Reviewer 2

The manuscript by Qiu and colleagues analyzes future projections from models included in the Coupled Model Intercomparison Project Phase 6 (CMIP6), with a focus on carbon fluxes in the northern high latitudes (NHL) compared to rest of the globe. The authors find that the CMIP6 models project terrestrial ecosystems to remain carbon sinks, with net sequestration rates increasing with global temperature changes, and that NHL ecosystems are a relatively minor fraction of the net sink but considerably more uncertain than the global mean.

Figure. Unrealistically high NEP from FLUXCOM.

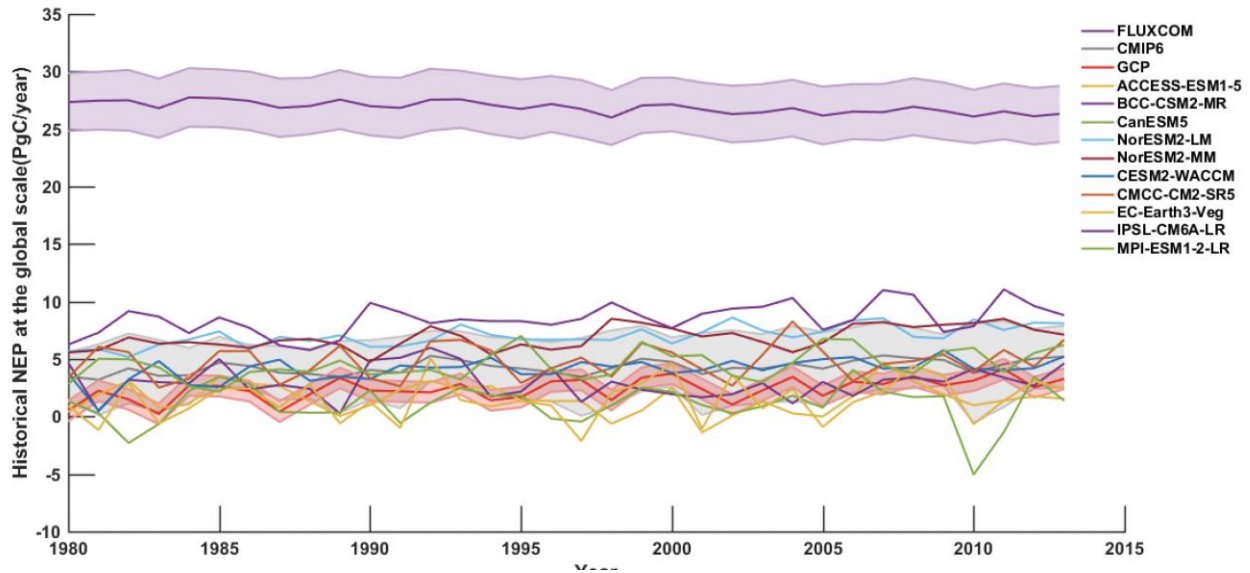
Personally, I also believe a manuscript such as this that discusses future carbon budgets would benefit from a historical comparison to data. This may be beyond the scope, but how should readers interpret the large differences between CMIP6 models and the GCP, and what does this ultimately mean for the future projections? Do models that tend to represent historical properties better (e.g., upscaled carbon fluxes from FLUXCOM, global biomass, LAI, etc.) tend to project higher or lower carbon sinks? These are important questions, some of which could be addressed in the Discussion and brining in past literature. Along similar lines, the Discussion could benefit from more context and interpretation. Why haven't uncertainties been reduced throughout CMIP versions, how would including permafrost carbon and disturbances change the assessment, what are the major recommendations on ways forward considering this?

Response: Thanks for the insightful suggestions. We extended our discussions on the historical comparisons by using the GCP data. In fact, we tried to use FLUXCOM NEP product to benchmark the CMIP6 models, but we finally decided to not include the results in the paper because of the large uncertainty of FLUXCOM NEP in the high latitudes (personal discussion with the developer of FLUXCOM; pasted below). We agree that LAI is a useful variable for understanding the uncertain CMIP6 carbon fluxes. Thus, we added discussion on CMIP6-estimated LAI, which has been suggested to be biased with high uncertainty by multiple other independent studies. These additional discussions provide our understandings of the uncertainties throughout CMIP versions and the recommendations for the future modeling efforts.

no, no conversion factor needed. It's unfortunately true that the mean NEE is not realistic. It seems to be mainly a problem of biased flux tower data in the tropics. It is discussed [here](#).
